1670 Tenth Line Road

Planning Rationale

October 17, 2025

Proposed Zong By-law Amendment & Site Plan Control Application – 1670 Tenth Line Road

Figure 10. Site Plan

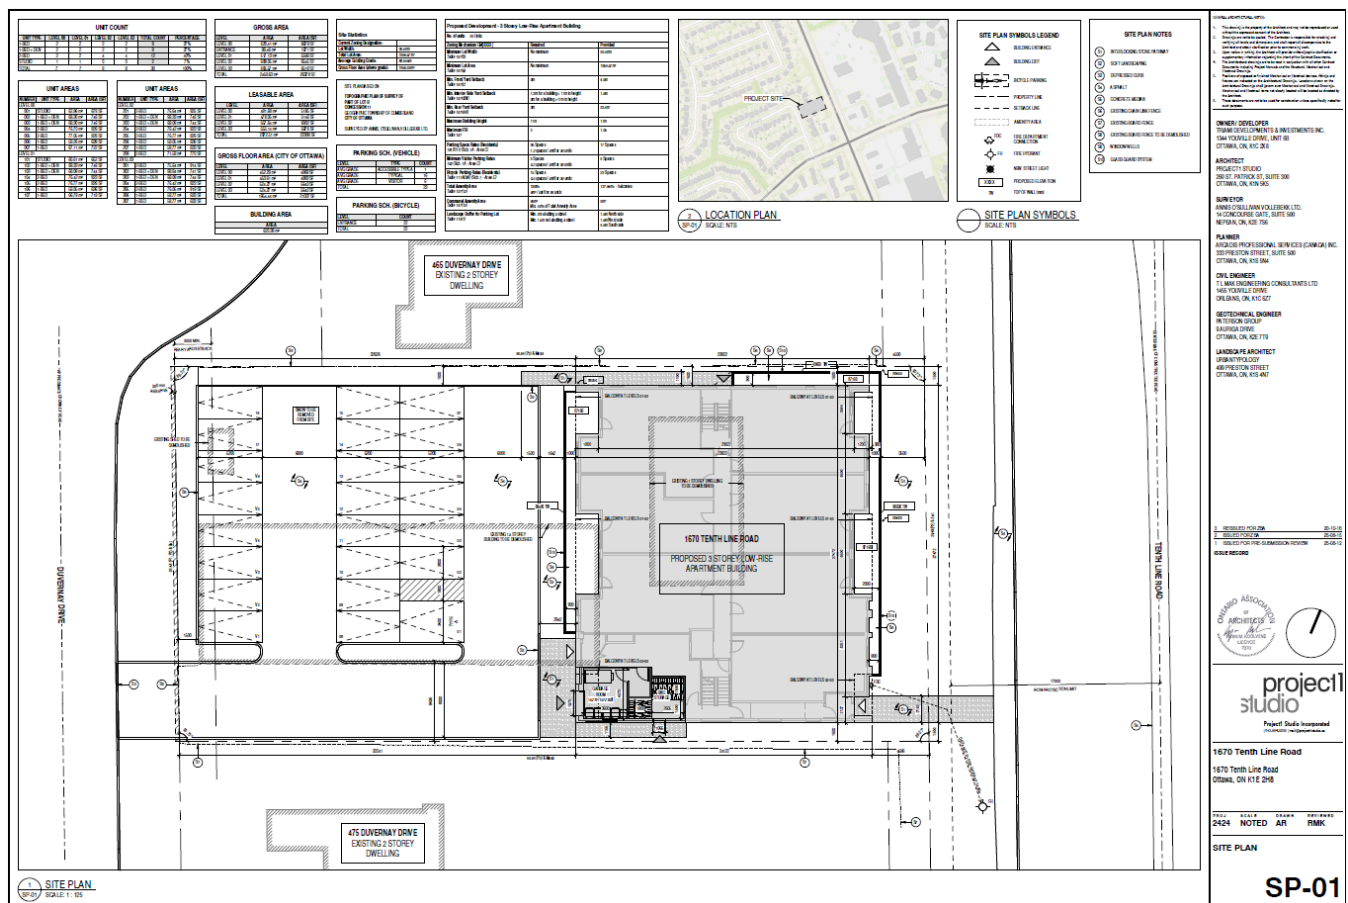
- a) *Screening of the parking lot to the rear abutting the residential neighbourhood. Provide a minimum 3m buffer on the property to provide landscaping.*

- c) *Remove the drive aisle to Tenth Line at Planning's request.*

9. Please provide landscaping around the below grade unit/window.

While only a 1.5 m buffer is provided between the rear parking lot and the lot line, there remains approximately 7.5 m of soft landscaping between the proposed parking and the public roadway, providing adequate buffer between parking and the surrounding residential neighbourhood. The landscaped area to the rear of the parking lot is proposed to include new tree plantings including three large deciduous trees and one medium deciduous tree, providing a screen between the parking lot and the surrounding neighbourhood. Additionally, the existing cedar hedge and fence on the northern limit of the site will remain, screening the parking lot from the existing residential development directly to the north.

The site plan is configured to provide the most optimal and efficient layout. Amenity area of all units is provided via balconies, including window well terraces for basement units.

Three large deciduous trees and one medium deciduous tree are proposed to be planted along the Duvernay Drive ROW. Five medium deciduous trees are proposed to be planted along the Tenth Line Road ROW.

Windows for below grade units are prominently located on the east and west facing facades. In these locations, planting strips for shrubs are provided. The existing cedar fence on the northern limit of the subject site is proposed to be retained, providing additional landscaping features to below grade units with windows on the northern façade.

Figure 1: Proposed Site Plan

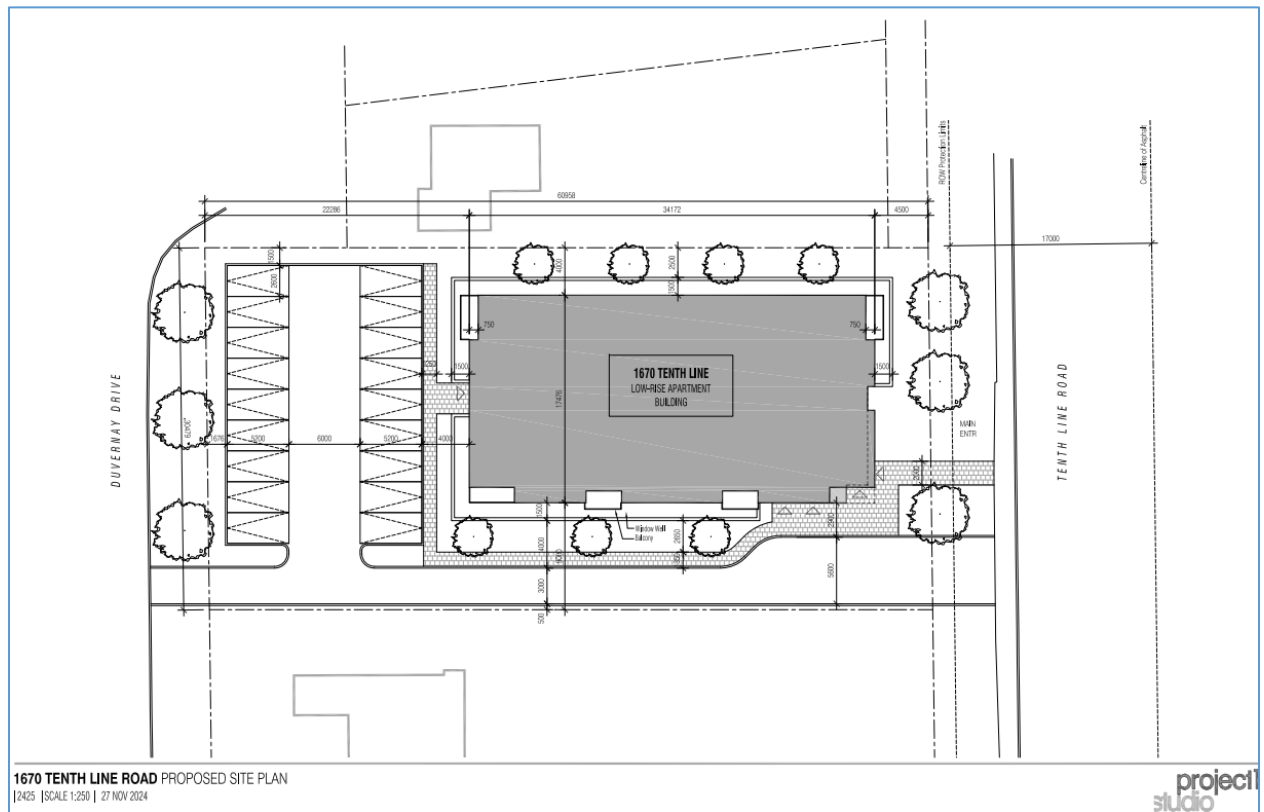
7. The following element of the preliminary design are of concern:
 - a. Screening of the parking lot to the rear abutting the residential neighbourhood. Provide a minimum 3m buffer on the property to provide landscaping
 - b. Window Wells surrounding the building. Perhaps larger area could be provided to allow usable amenity area to basement units.
 - c. Remove the drive aisle to Tenth Line at Planning's request.
8. Street trees should be provided along the abutting Right-of-ways (ROW)s.
9. Please provide landscaping around the below grade unit/window wells to provide transition to surrounding properties and privacy for residents.

- a. Revise Screening For following the removal of the proposed access onto Tenth Line Rd. As an access will not be provided, a TIA will no longer be triggered.

38. On site plan:

- g. Show dimensions for site elements (i.e. lane/aisle widths, access width and throat length, parking stalls, sidewalks, pedestrian pathways, etc.)
- h. Provide sidewalk along Duvernay frontage.

- k. Provide pedestrian connection to Tenth Line Road sidewalk.

47. A reduction in the landscape buffer is generally not supported. Please provide justification for why this is necessary, and development of the site relies on it.
